TOWN OF MILFORD, NH
OFFICE OF COMMUNITY DEVELOPMENT

Date: September 15, 2022
To: Planning Board
From: Camille Pattison, NRPC Assistant Director
Subject: SP2022-08 Sooner Transportation LLC, for the property located at Tax Map 12, Lot 11, 754-756 Elm Street (Horseless Carriage Site). Public Hearing for a Major Site Plan Application to construct a two-story, 10,320 sf. auto sales and repair facility with associated parking, stormwater management/drainage, landscaping, and lighting improvements on the subject property located in the Commercial 'C' Zoning District and West Elm Overlay District.

Re: September 20th Planning Board Meeting Discussion
Sooner Milford Site Plan
754-756 Elm St
Map 12 Lot 11

TAX MAP 12 LOT 11
ARCHITECTURAL & TRUCK TURNING PLAN
SOONER-MILFORD
 LOCATED AT:
754-756 ELM STREET
MILFORD, NEW HAMPSHIRE, 03055
 OWNER: LAND BARGE, LLC
 754-756 ELM STREET
 MILFORD, NH 03055
 APPLICANT: SOONER TRANSPORTATION LLC
 3 EXECUTIVE PARK DRIVE, SUITE 2016
 BEDFORD, NH 03110

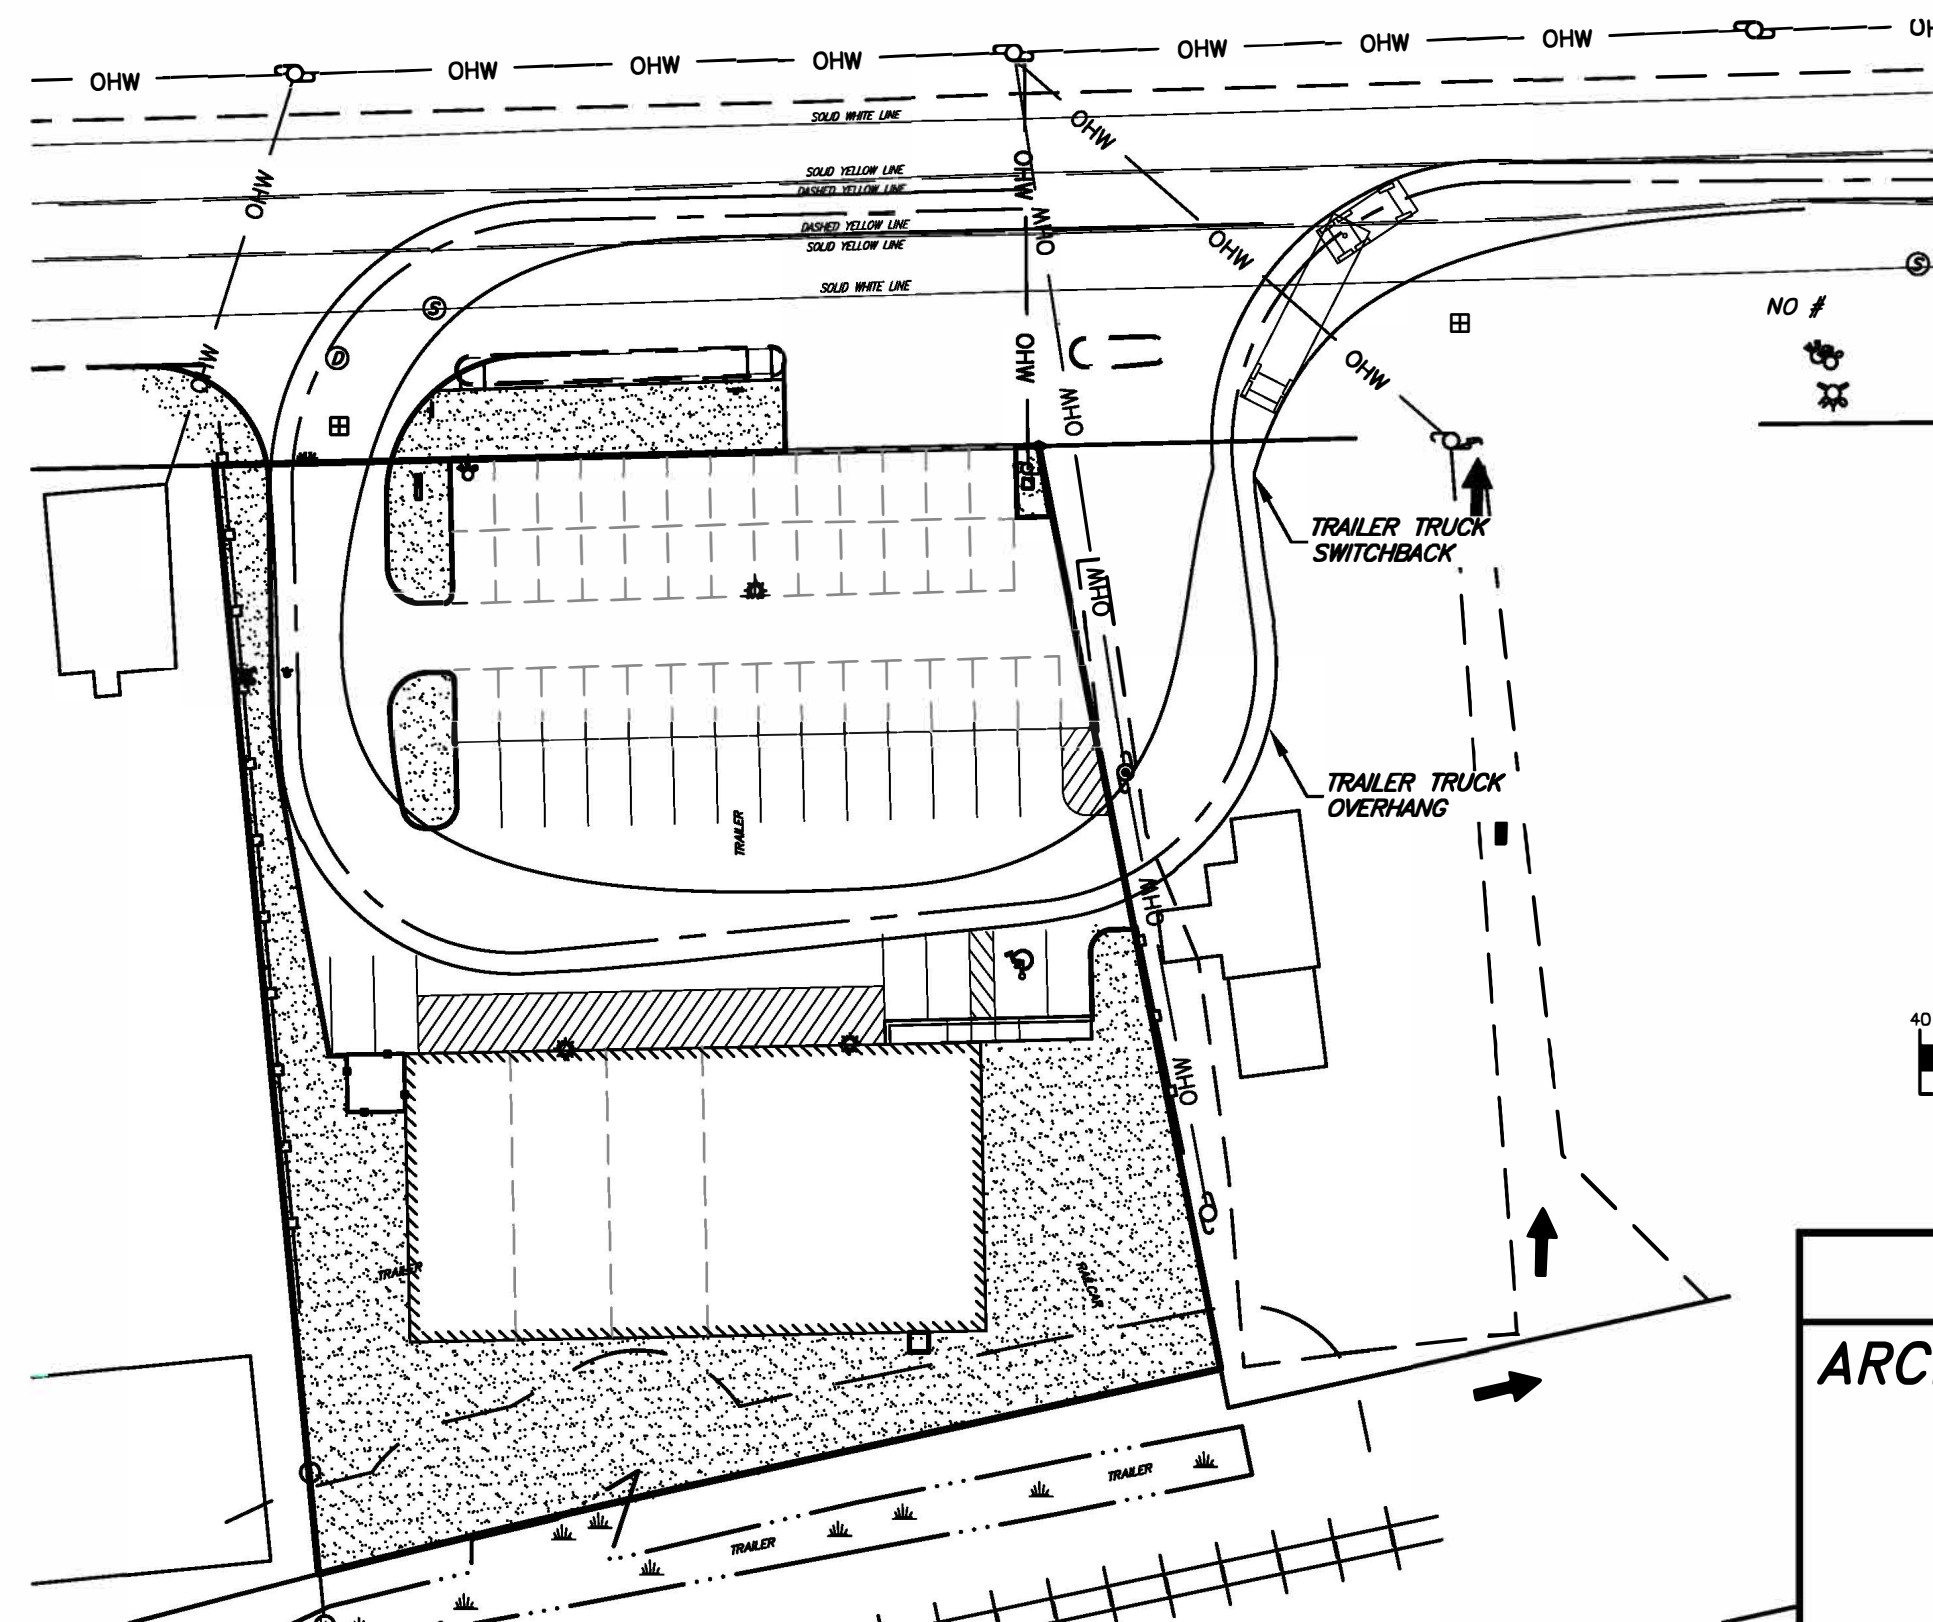
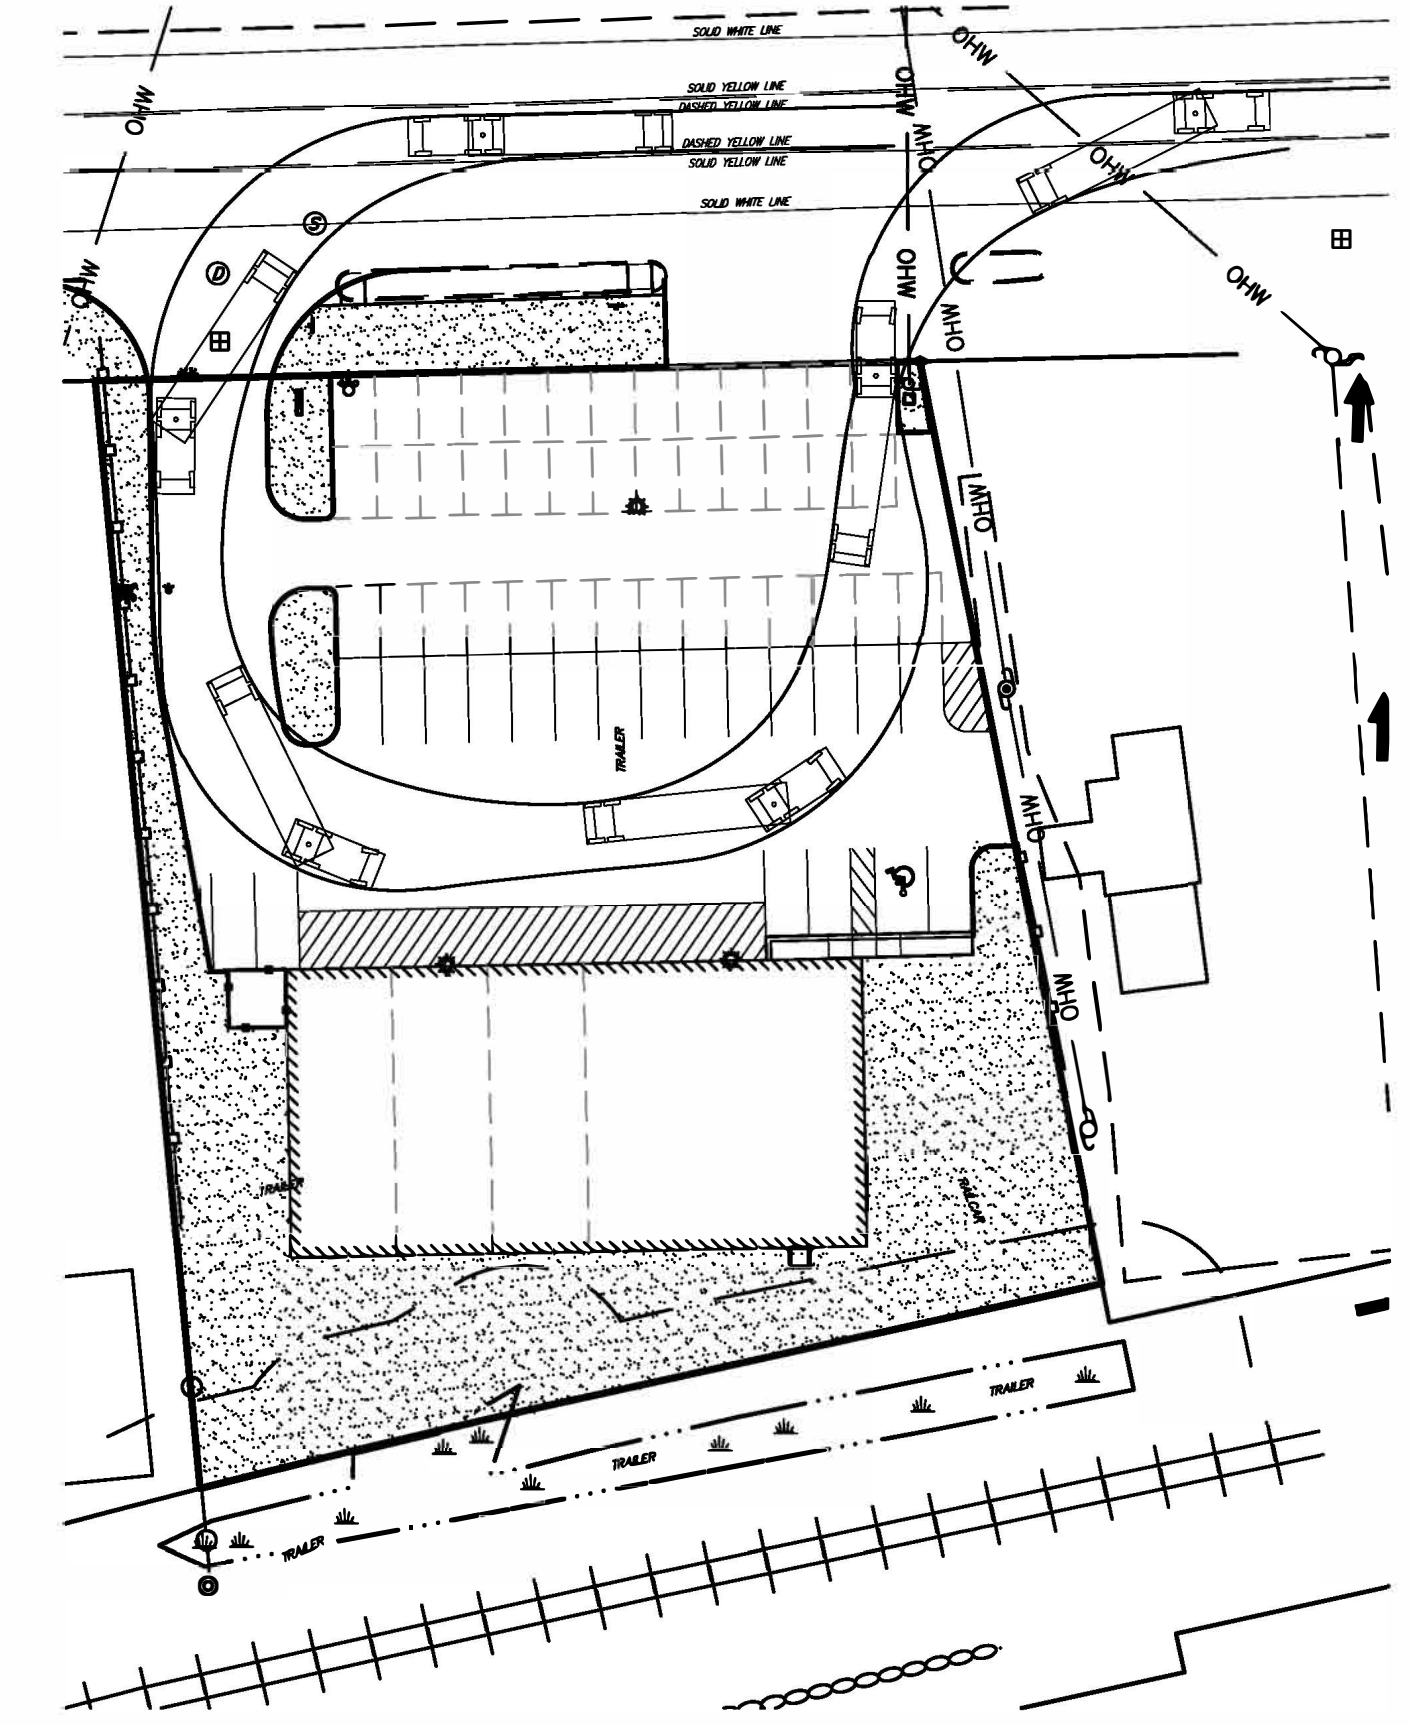
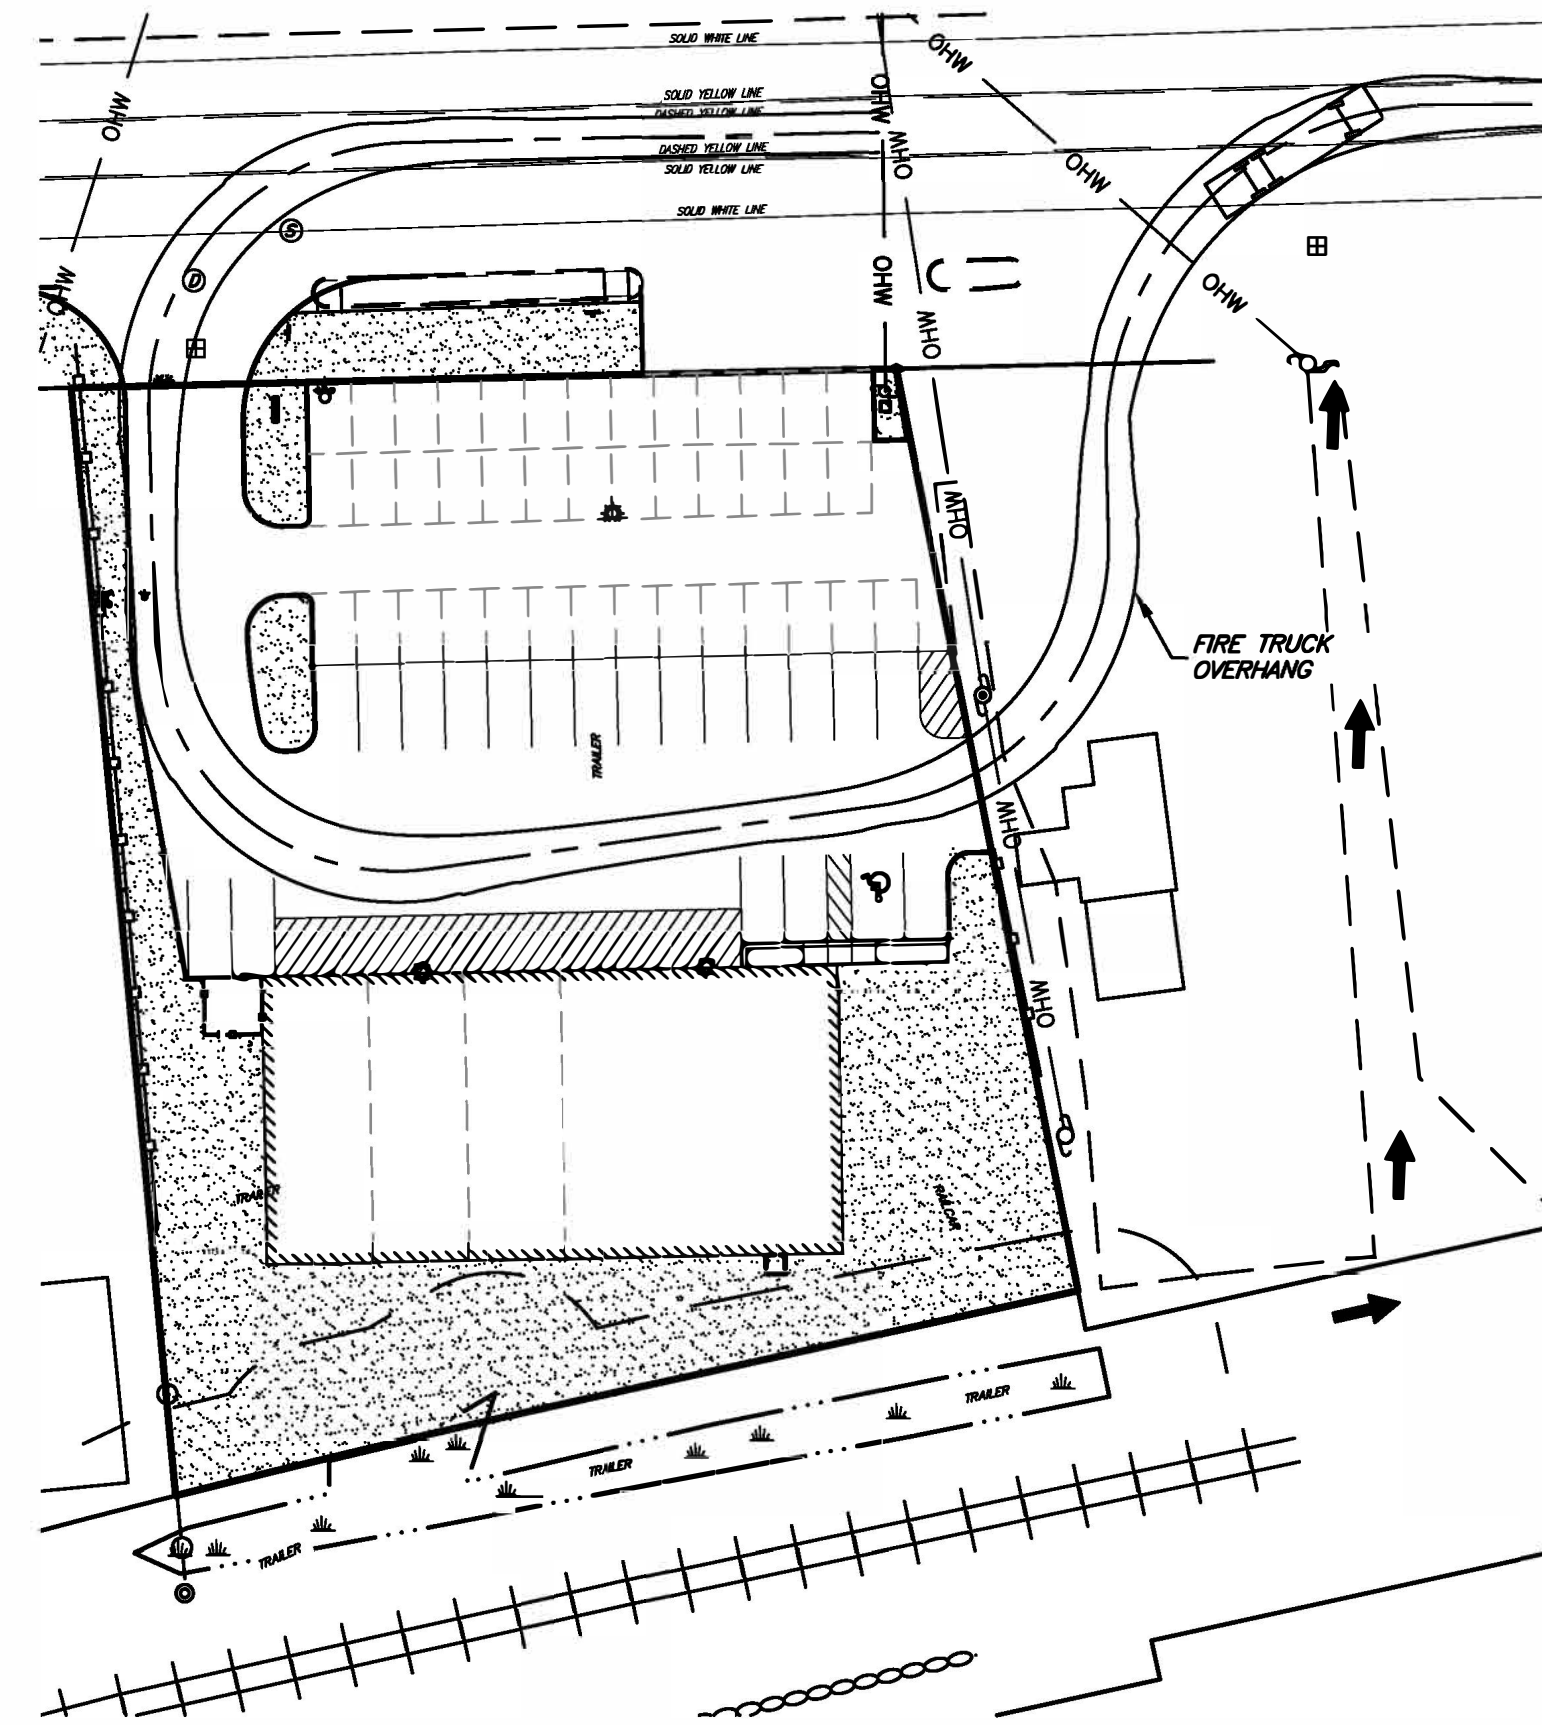
15. Sheets 1 and 6 - Pursuant to the Zoning Ordinance, Section 6.07.6.E.1.a, a new structures shall maintain an appropriate street edge in relationship to adjacent structures. The location of the proposed building is set within the rear section of the property, which conflicts with buildings located to the east and west.

16. Sheets 1 and 6 - Pursuant to the Zoning Ordinance, Section 6.07.6.E.2.b, the proposed building should enhance the definition of each floor of the building through terracing, material changes, articulated structural elements, changes in materials and horizontal trim bands. The applicant should explain how the proposed building complies with this section.

17. Sheets 1 and 6 – Please explain how the proposed building architectural features and materials comply with the Zoning Ordinance, Section 6.07.6.E.3.

18. Sheets 1 and 6 – Pursuant to the Zoning Ordinance, Section 6.07.6.E.4.a, the proposed building design should avoid blank walls at ground-floor levels through the use of windows, trellises, material changes, arcades, or other features to increase visual interest. The applicant should be prepared to discuss how the proposed building complies with the section.
